CS28 - Existing Plan  
1 : 20

CS28 - Proposed Plan  
1 : 20

Project Office, Room 308, Town Hall, MANCHESTER M60 2L1  
+44 (0) 7970 097 432  
www.purcelluk.com

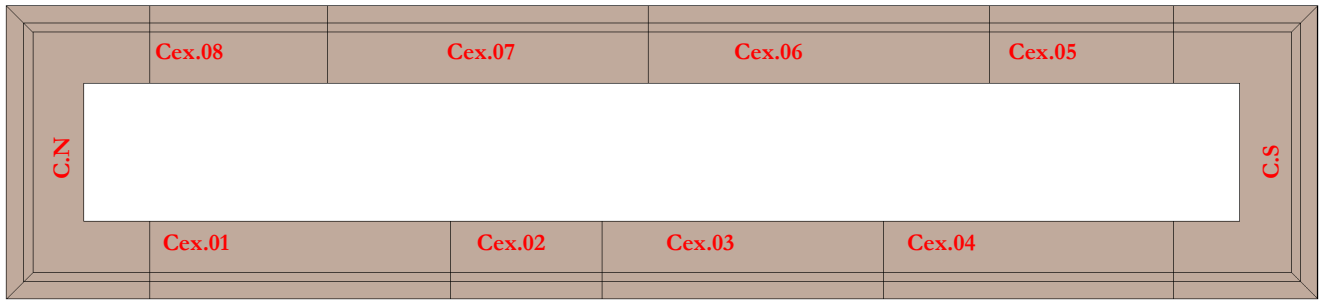
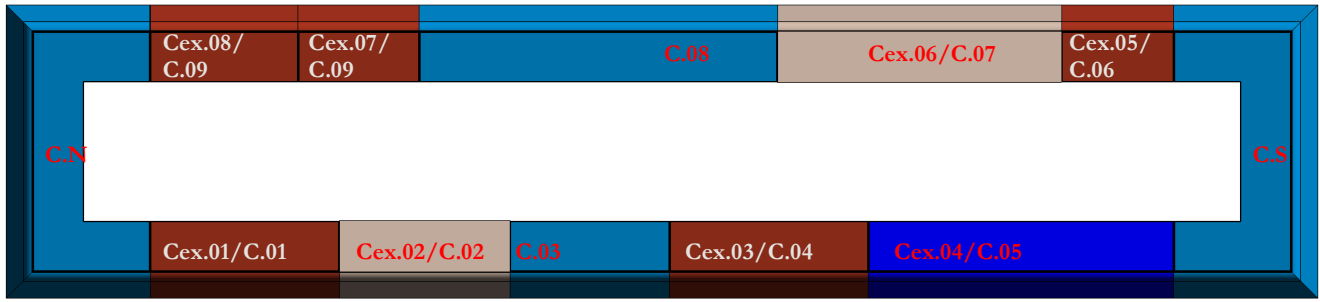
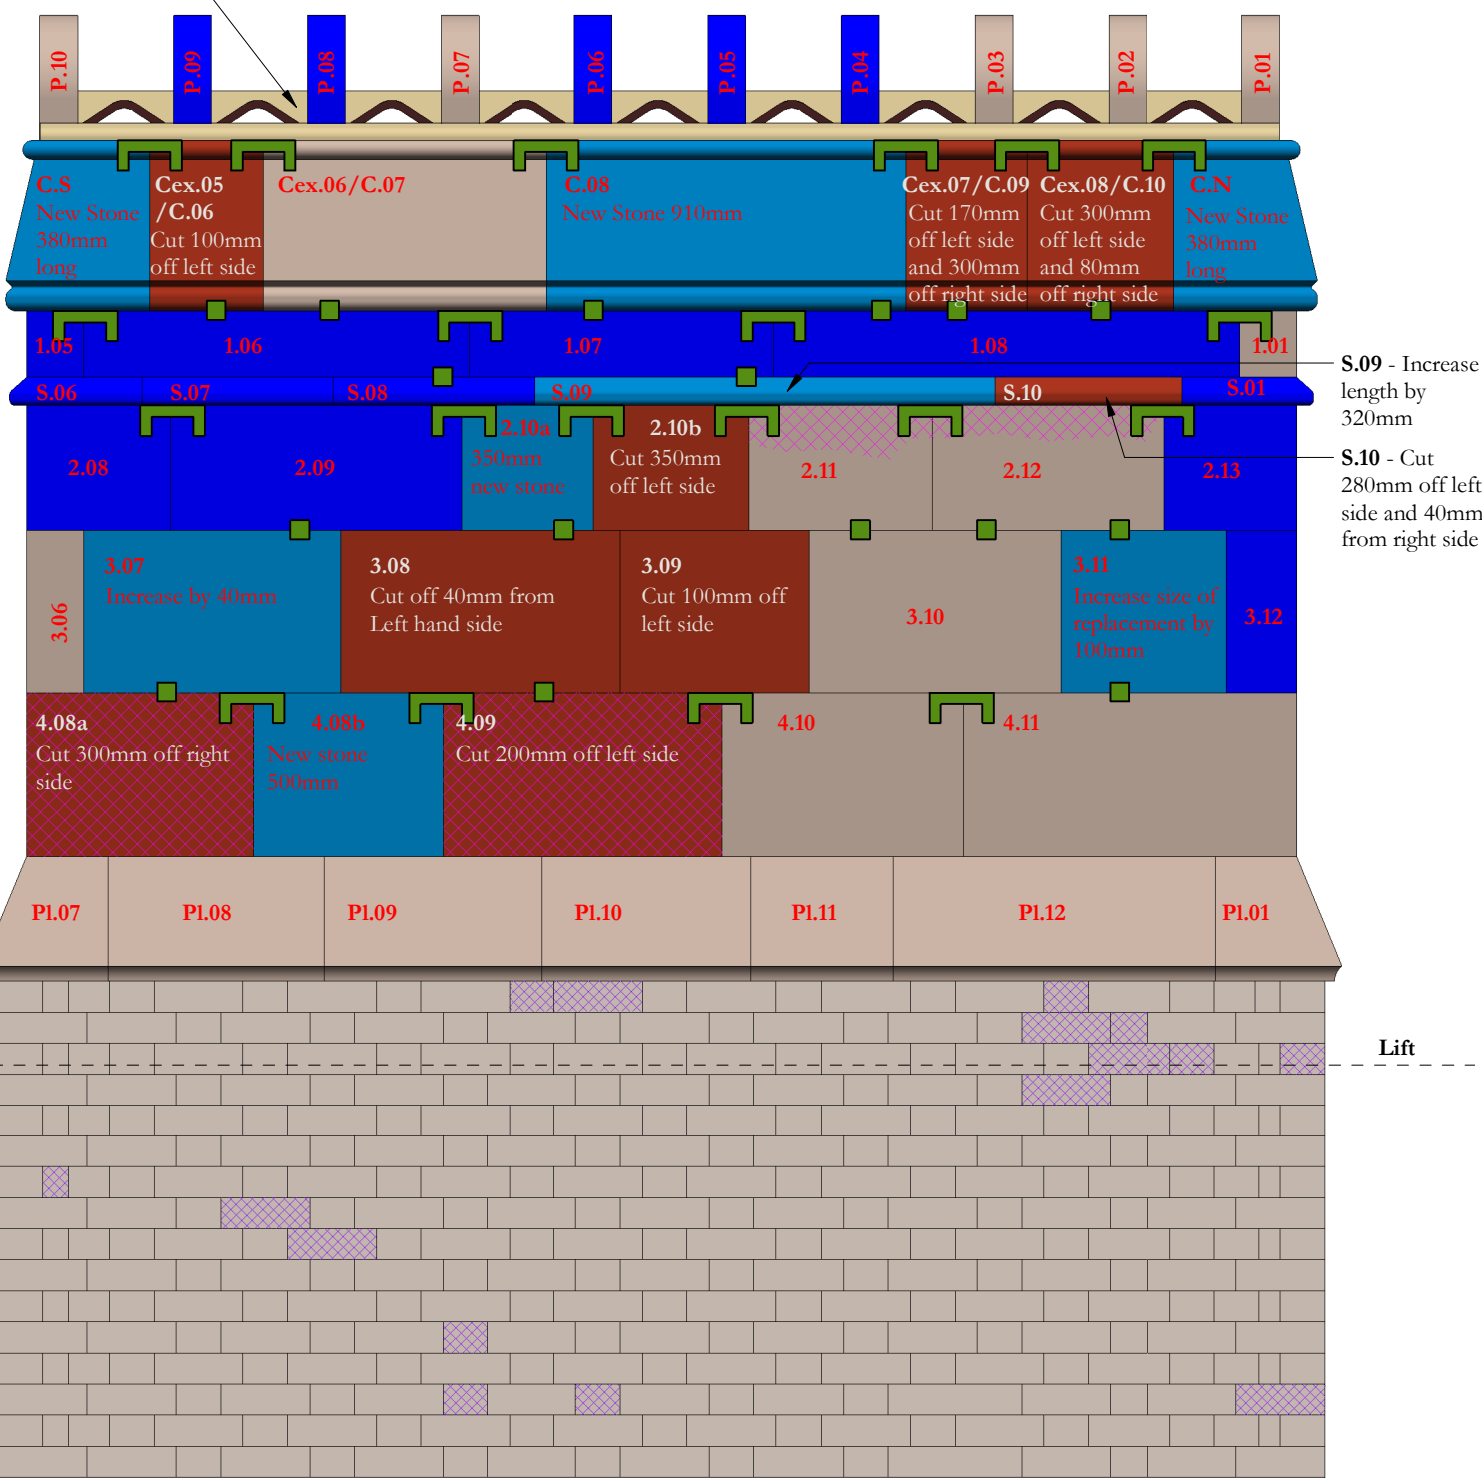
**Revision 02**  
Alterations to string course stones S.02, S.03, S.06 and S.07 omitted. String course stones S.01, S.02, S.03, S.06 and S.07 to be replaced. Increase in length of replacement stone S.08 to be omitted with like for like replacement substituted. 40mm to be cut off end of S.04 with length of S.03 adjusted. Stones 3.01 and 4.06 to be replaced. Damaged sections of stones 3.04, 3.05 and 3.08 to be cut off. New stone 3.04a added and length of new stone 3.07 increased. Cramp locations to moved from top of string course to top of course 2 and new cramps added to top of course 4 and across feathers.

**Revision 01**  
Drawing updated to construction status following validation survey
